The attached material is submitted in response to your July 20, 1979 request for additional information regarding the Refueling Water Storage Tank (RWST) capacity.

DIABLO CANYON, UNITS 1 & 2

REQUEST FOR ADDITIONAL INFORMATION

PIPING SCHEMATIC
 REFUELING WATER STORAGE TANK
 DIABLO CANYON

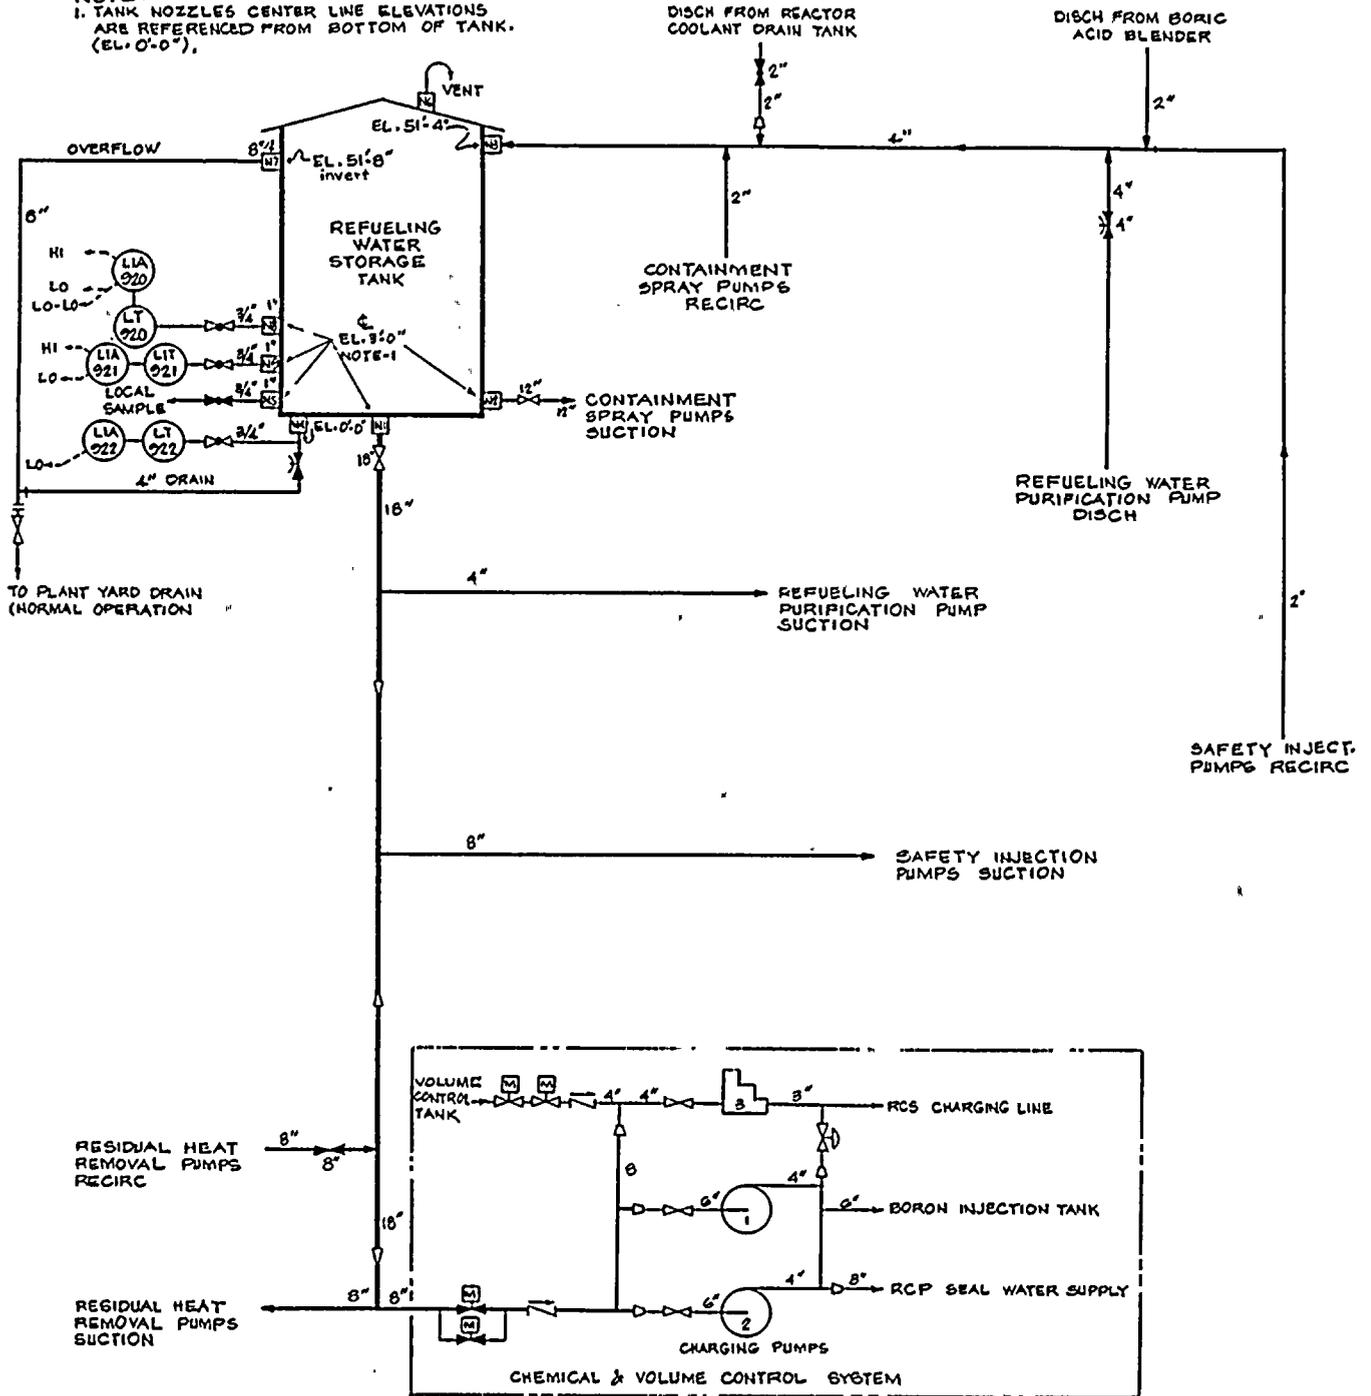
Question 2: Show that there is sufficient capacity to prevent formation of a vortex and entrapment of air into RWST piping. Reference a test demonstrating sufficient tank capacity to prevent vortex formation while pumps continue to take suction on the RWST. Test considerations should include the most limiting single failure (e.g. no manual actions). Provide the total tank capacity and tank dimensions, include a dimensioned schematic drawing of tank and connecting pipes.

Answer: There is sufficient capacity in the tank to prevent vortex formation or entrapment of air. The tank low-low level alarm has been set so that even, in the case of worst instrument error, water level will not fall below the top of the vortex preventing cage. This cage has been designed by a consultant on the basis of full scale tests of pump suction flows. The tests showed that this design will prevent the formation of vortexes and the resulting entrainment of air, as long as the water level does not fall below the level of the vortex cage.

The tank is forty feet in inside diameter and 52'-6" high to the roof line. This is a total volume of 492,000 gallons. There is an eight inch overflow connection 51'-8" above the tank floor so the practical total tank capacity is 484,000 gallons. The high level alarm is set 49'-11" above the tank floor giving a full tank total volume of 468,000 gallons. A dimensioned schematic drawing of the tank is attached.
